FUJIFILM ENGINEERING CHANGE NOTICE (FIELD CHANGE NOTICE)

SUBJECT: Releasing the information of DR-ID300CL Application Software V8.1
 (for Software licence unsupported version)

AFFECTED PRODUCTS: DR-ID300CL

CL Application V8.1 for DR-ID300CL, including new functions and error corrections, is ready to be released.

TightVNC installer

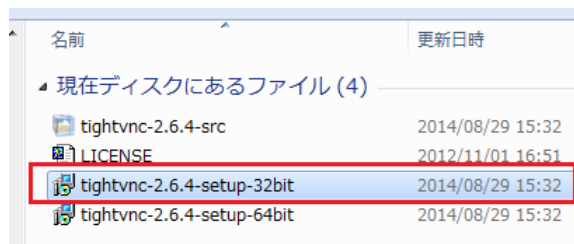
From V8.1 onward, TightVNC installer is mounted in the Application Software installation DVD. Be sure to use “\tools\VNC\TightVNC\tightvnc-2.6.4-setup-32bit.msi ” when installing TightVNC.

Measure screen:

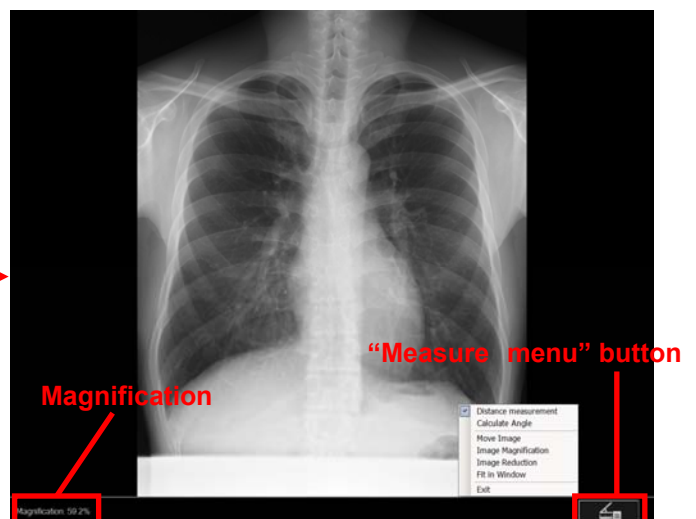
* "Measure" button is disabled in Tomosynthesis menu.

■ Distance measurement

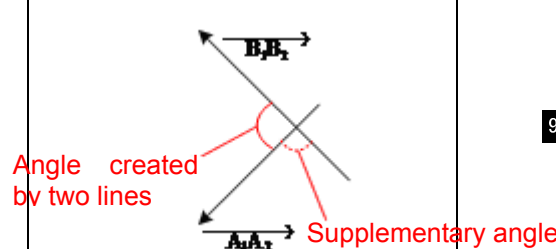
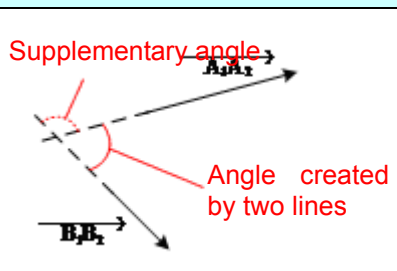
The distance of any position within the image can be measured and the results can be displayed on the screen.

- Display specification of the distance measurement result:
 - Precision: Calculated to the second decimal place (value rounded off to the second decimal place)
 - Unit: mm/inch(in accordance with service settings)
- Can move the distance measurement result to any place within the image display region. Measurement result can also be deleted.
- Can set the color of line (common to angle measurement) in the Service Settings.
- Can measure a maximum total of 16 points together with the angle measurement result.
- Measurement result correction:

- If the magnification ratio can be received from Xcon, the measurement result is adjusted according to the ratio in the case of magnified exposure.
- In the case of general exposure, if SID and STD are received from Xcon, the measurement result is adjusted according to the magnification ratio calculated with SID and STD. If SID and STD are not received from Xcon, the measurement result will not be adjusted.
- When the measurement result is adjusted, a "#" mark that describes adjustment completion appears at the end of the measurement result.

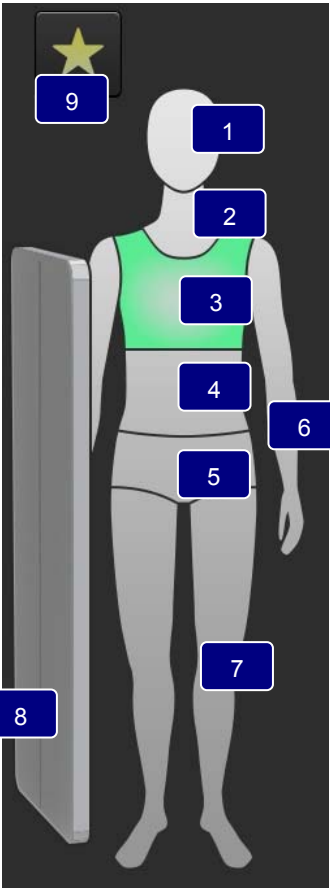
The factory default for abstract illustration parts of human body and exposure menu is as follows in Graphical.

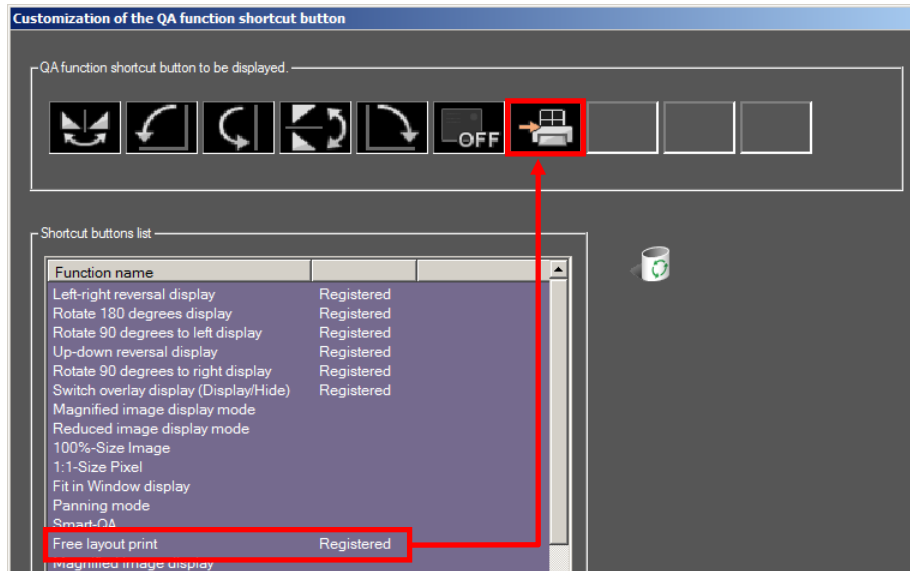
Set enable/disable for “Free layout print” in “Customizing the screen display” -> “Customization of the QA

function shortcut button”.

Setting of *Service Utility “Enable Free Layout Print In Study” is enabled

5.1. Overview

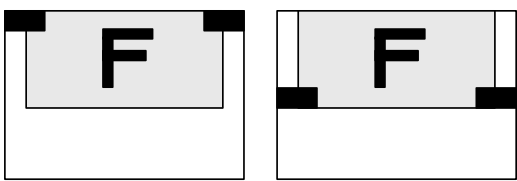
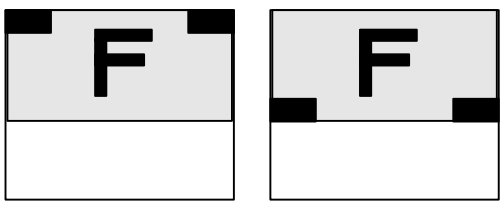
A blank margin appeared at the top of film when pantomography image (15cm x 30cm) was film printed. Therefore, we added formats (3 patterns) to top align images in V8.1.

Specification of the additional format is similar to that of CR Console. Note that DR images are also subject to this format.

Radiation field information column

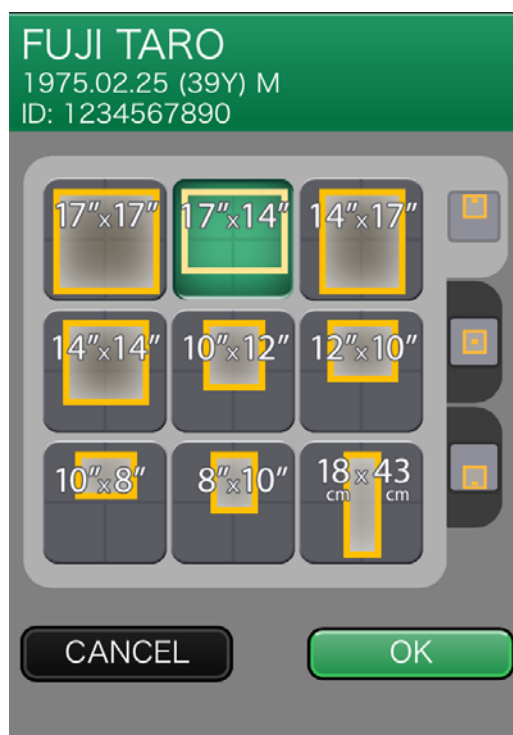
- Displaying the Radiation field information on the exposure menu

Displays the following Radiation field information that is set in the exposure menu.

- Radiation field size
- Exposure standard position
- Exposure orientation (expressed by length and width of display size)

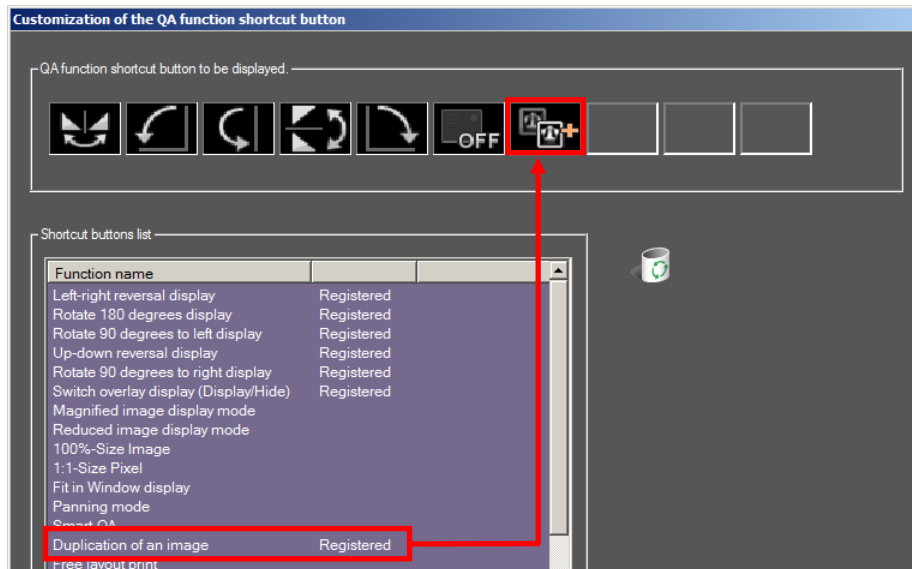
“Customizing the screen display”->“Customization of the QA function shortcut button” screen. Set the “Duplication of an image” button to enable or disable.

*Be sure that Service Utility “Enable Copy Image” setting is enabled.

■ Processing flow in V8.1

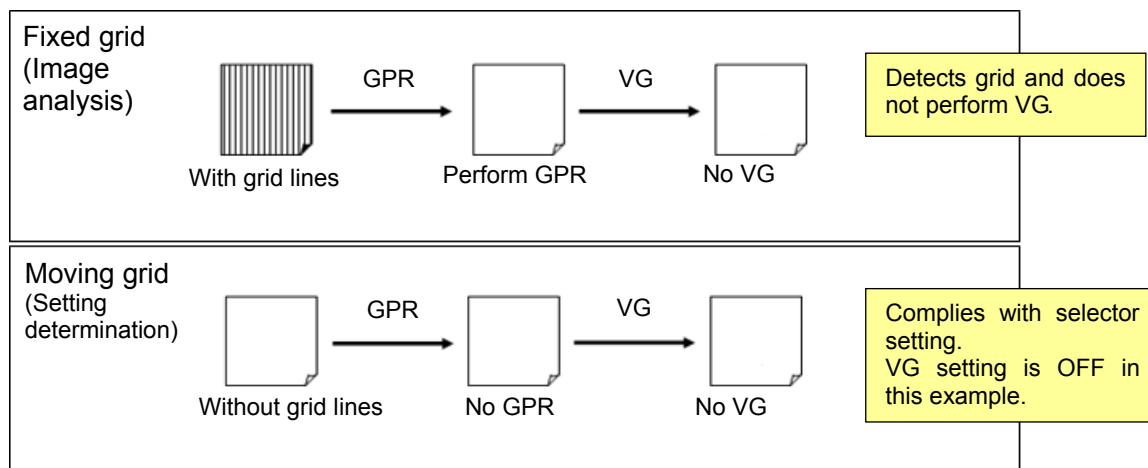
■ Processing flow in V8.0
